Summerlin West V21 Parcel 1 - Stockpile Permit

CITY OF LAS VEGAS		DATE:
INTER-OFFICE MEMORANDUM		May 28, 2019
TO: Land Development Services Department of Building & Safety		FROM: Albert Sung, P.E. Flood Control Project Engineer Department of Public Works
SUBJECT:	Drainage Study for:	
	Summerlin West V21 Parcel I – Stockpile Permit	
Cross Streets:	NEC of Carriage Hill Drive & Redpoint Drive	COPIES TO:
File Number:	F:\Depot\DSMemos\DS5137A.doc	VTN Nevada
Parcel Number:	137-26-101-001	Howard Hughes Company, LLC
Zoning Action:	N/A	Bart Anderson, P.E., DevCo
FEMA Flood Zone	YES	NO X
Proposed Storm Drain	YES	NO X

The Drainage Study for the subject project has been reviewed and:

GRADING PLAN 1
SUMMERLIN WEST VILLAGE 21
PARCEL 1 STOCKPILE

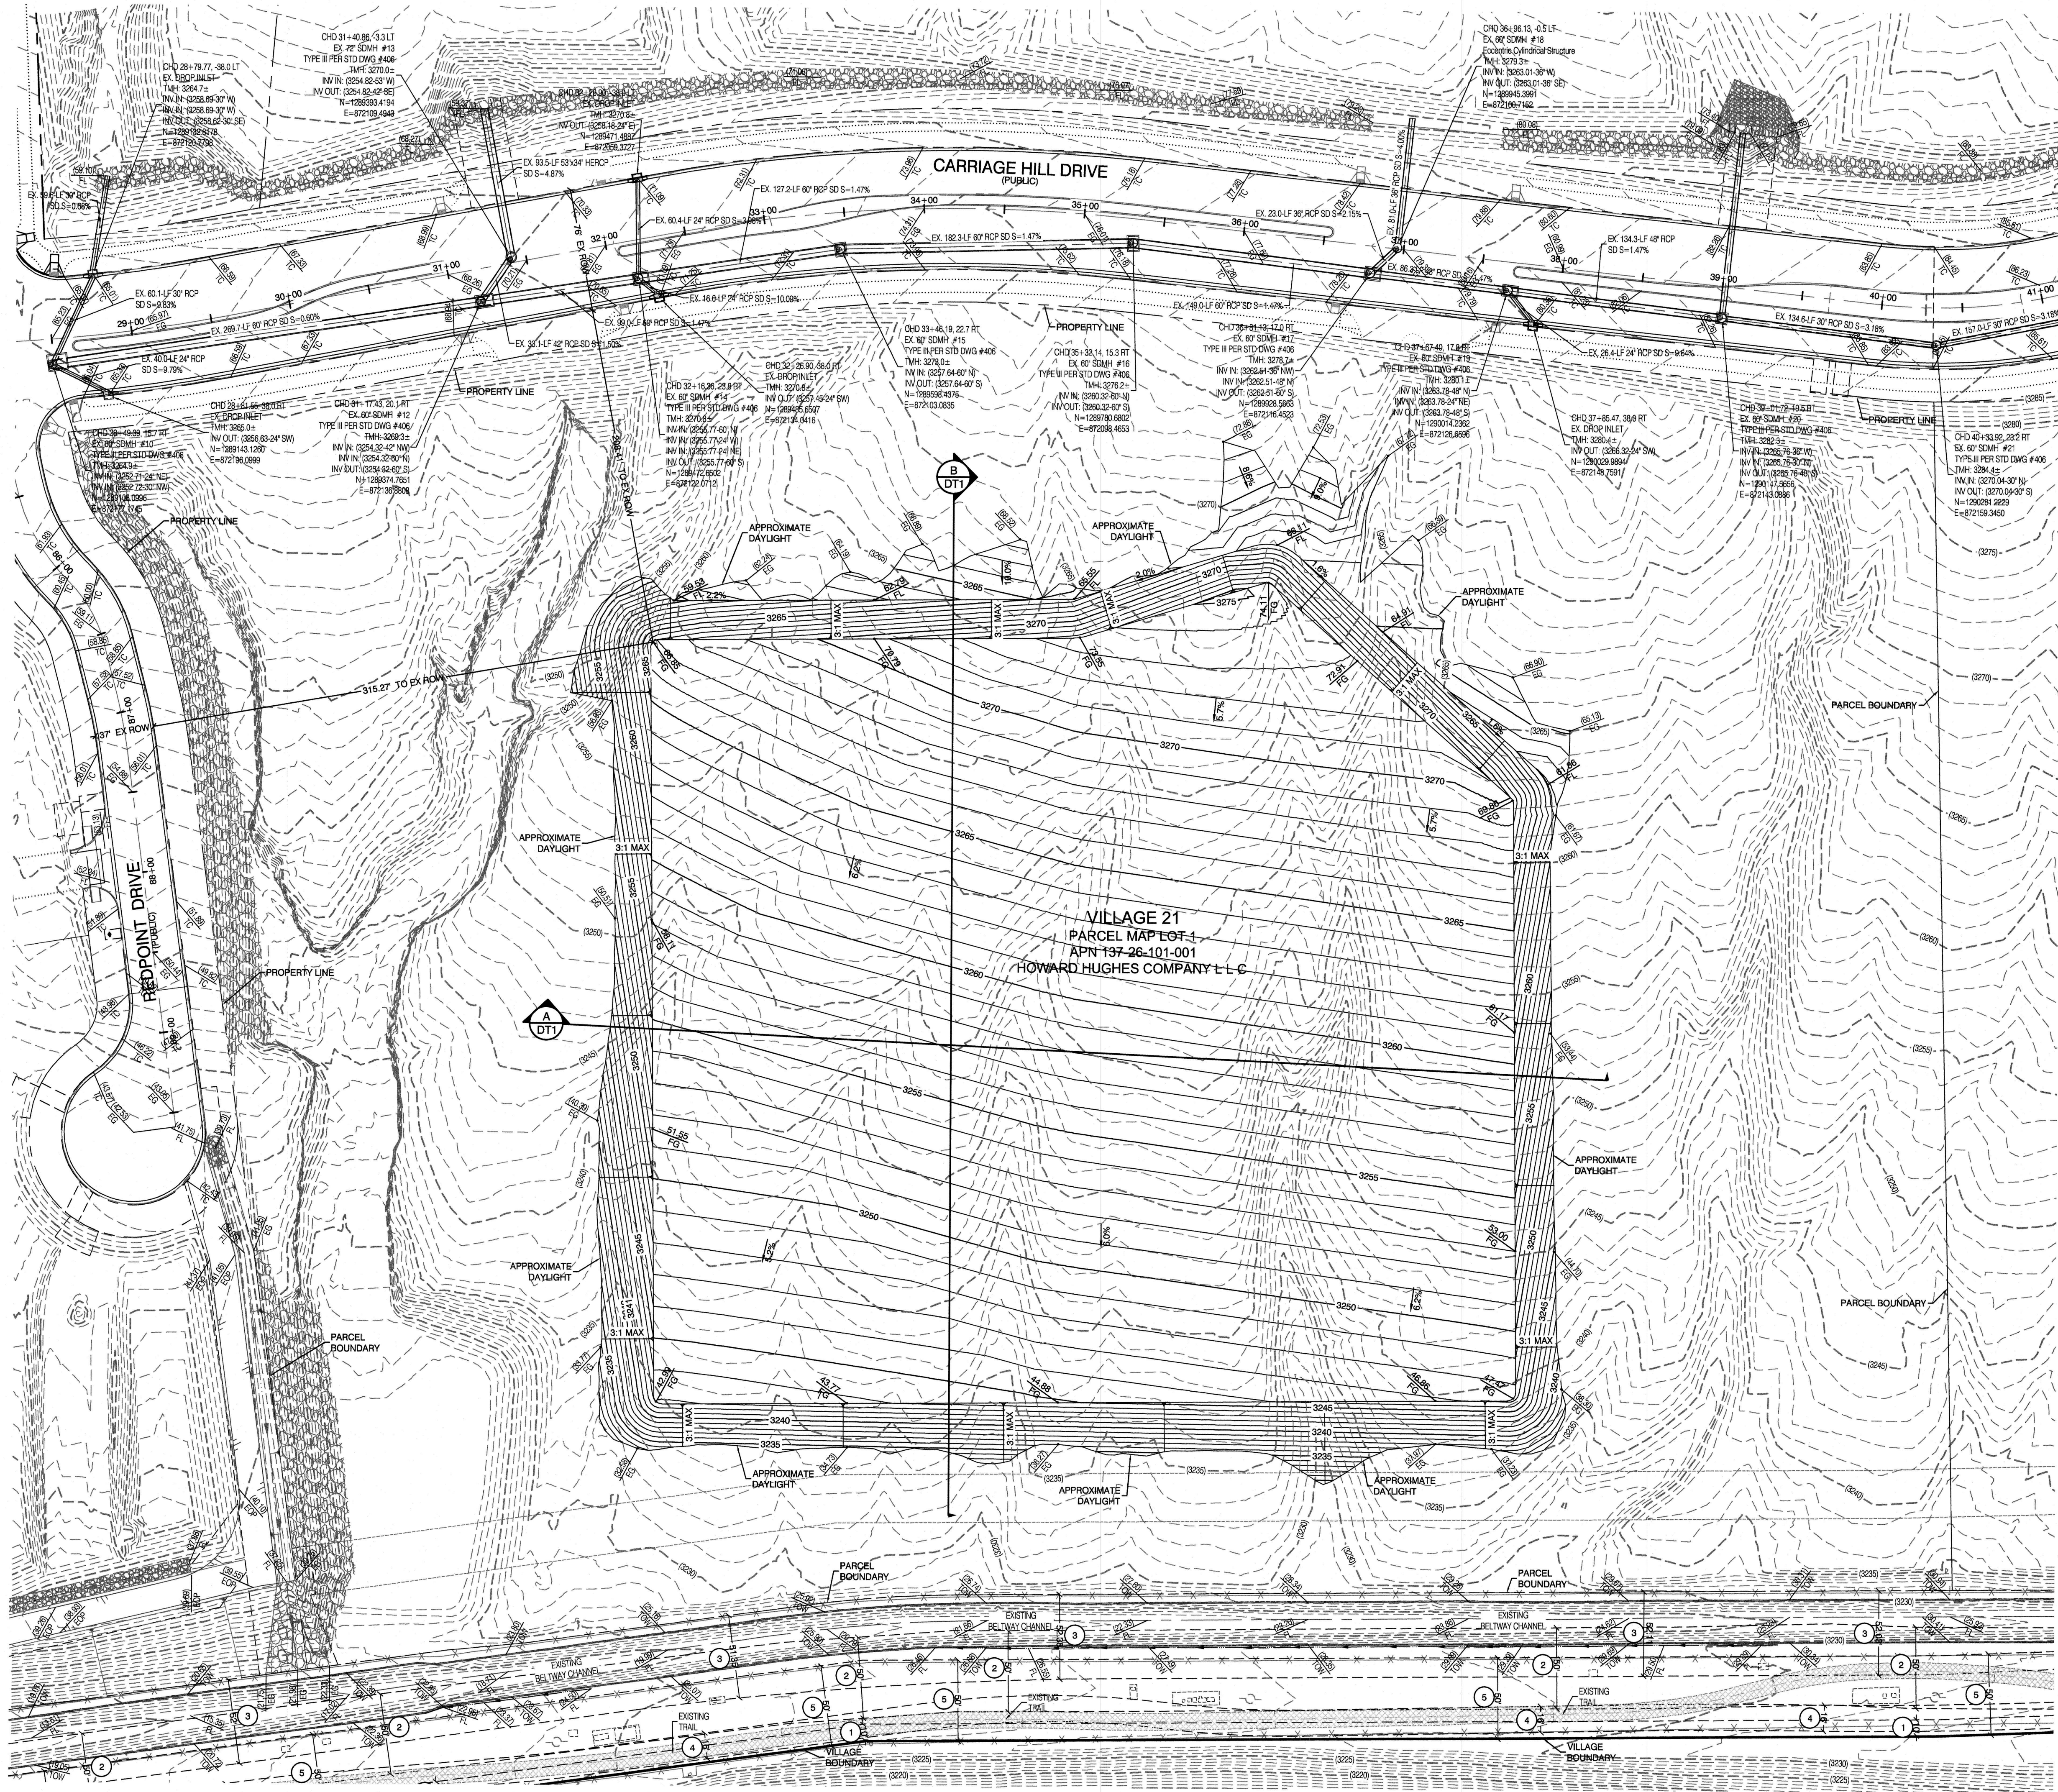
1. The City will not issue a stockpile permit prior to the *Dust Mitigation Plan* approved by the Clark County.

Provide a note on the grading plan that states "Stockpile to comply with approved Clark County Dust Mitigation Plan # _____".
